Reigate & Banstead BOROUGH COUNCIL Banstead Horley Redhill Reigate	TO:	PLANNING COMMITTEE
	DATE:	22 nd January 2020
	REPORT OF:	HEAD OF PLACES & PLANNING
	AUTHOR:	James Amos
	TELEPHONE:	01737 276188
	EMAIL:	james.amos@reigate-banstead.gov.uk
AGENDA ITEM:	6	WARD: <i>Lower Kingswood, Tadworth and Walton</i>

APPLICATION NUMBER:	19/01514/OUT	VALID:	12/09/2019
APPLICANT:	Walton Heath Golf Club	AGENT:	
LOCATION:	WALTON HEATH GOLF CLUB, DEANS LANE, WALTON ON THE HILL		
DESCRIPTION:	Outline planning application with all matters reserved (excluding access) for the demolition of the existing buildings and provision of up to 13 residential dwellings, residential amenity space, associated car parking, access and associated works		
All plans in this report have been reproduced, are not to scale, and are for illustrative purposes only. The original plans should be viewed/referenced for detail.

SUMMARY

Drawing Proposed Outline Layout		Date Sep-19
Project/Client WHGC Redevelopment of Ex Clubhouse Site Walton Heath Golf Club		Scale @ A3 1:1000
Job Reference 02036 150	Revision Number P2	Purpose of Issue Approval

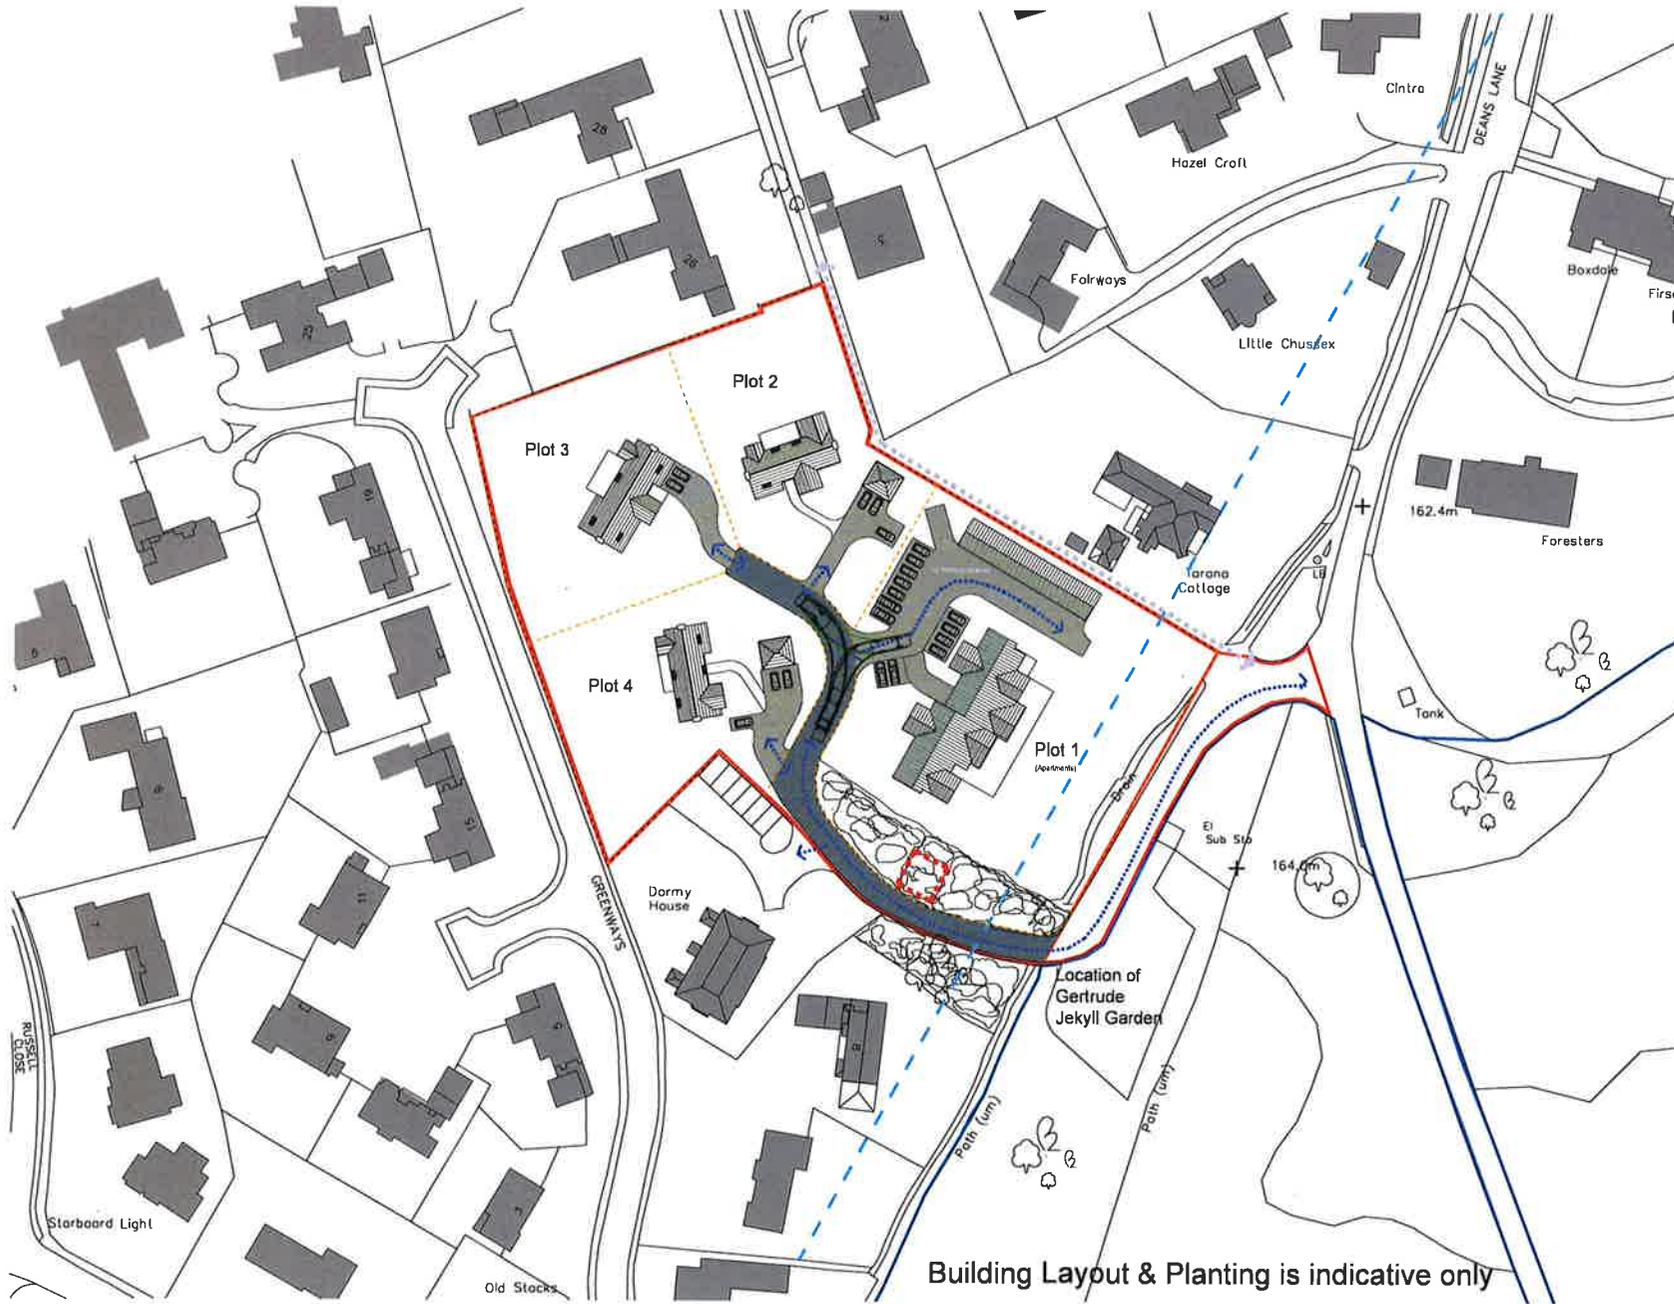
Conservation and Heritage Officer: Initially raised objections to scheme on design and conservation grounds. Those objections have been partially overcome by submission of revised plans. It is considered that the layout is generally acceptable with the reduction in the number of houses (to 3) but the scheme is still unacceptable due to;

- The apartment block encroaching on the historic garden designation.
- The ridge height and span of the apartment block roof being too wide and too high.
- The roof pitch being too steep.
- The illustrative form of the apartment block is not particularly satisfactory in terms of its staggered disjointed central break in the roof line and the lack of chimneys (contradicting the design code).

- 6.13 The Council's Conservation and Heritage Officer has reviewed the revised and is satisfied that the layout of three detached dwellings at the rear of the site is now acceptable and would preserve the character and appearance of the conservation area. However, it is considered that the proposed apartment block would be too large and would be located too close to the historic garden designation on the site. The Council's Conservation officer considers that the ridge height and the span of the apartment block roof would be too wide and too high. It is considered that the roof pitch would be too steep and that the illustrative form of the apartment block would not be satisfactory in terms of its staggered disjointed central break in the roof line and the lack of chimneys (contradicting the design code).

- 6.24 In response, the applicants have submitted revised plans which show a total of 31 car parking spaces on the site, including 10 covered spaces for the apartments, as well as open parking for the apartments and private parking for the proposed dwellings. The amount of parking now proposed would accord with the Reigate and Banstead Parking Standards.
